Florida Department of Transportation

SUBJECT: Temporary Design Bulletin C06-05
Roadway Design Bulletin 06-04
Policy for Miscellaneous Attachments to Traffic Railings / Barriers

Table 4.3.1 Minimum Offset of Barriers
(Measured from the face of the barrier)

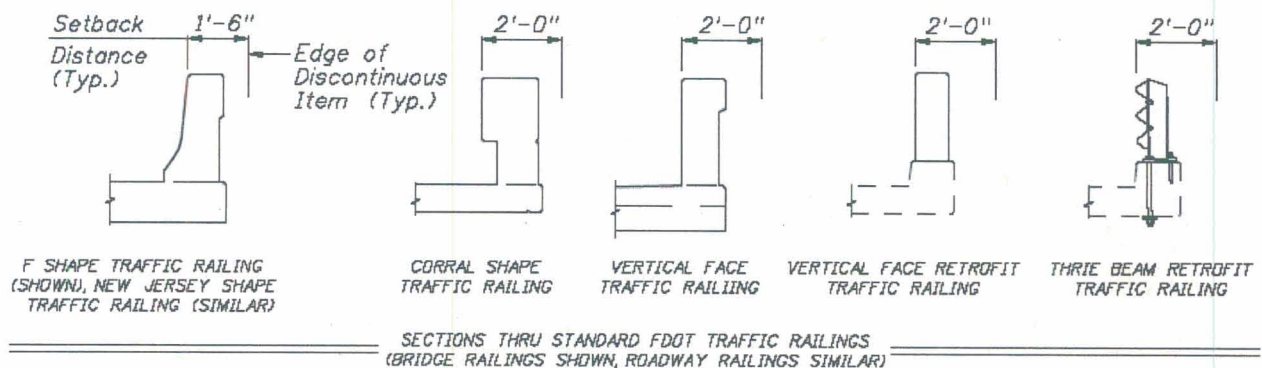
Delete Chapter 4, Table 4.3.1 of the January 1, 2006 PPM Volume I and replace it with the following:

BARRIER TYPE	OFFSET (ft)
W-Beam with Post Spacing @ 6'-3"	4.0
W-Beam with Post Spacing @ 3'-1 1/2"	3.0
Thrie-Beam with Post Spacing @ 6'-3"	3.3
Thrie-Beam with Post Spacing @ 3'-1 1/2"	2.6
Barrier Wall	0*
Double W-Beams (Nested) with Post Spacing @ 3'-1 1/2"	2.6
Double W-Beams (Nested) with Post Spacing @ 1'-6 3/4"	2.3

* Except where specifically provided for in the Design Standards, hazards that extend above the top of a barrier wall shall be offset a minimum 1.5' from the face of the top edge of F-shape barrier, and a minimum 2.0' from the face of vertical shape barrier.
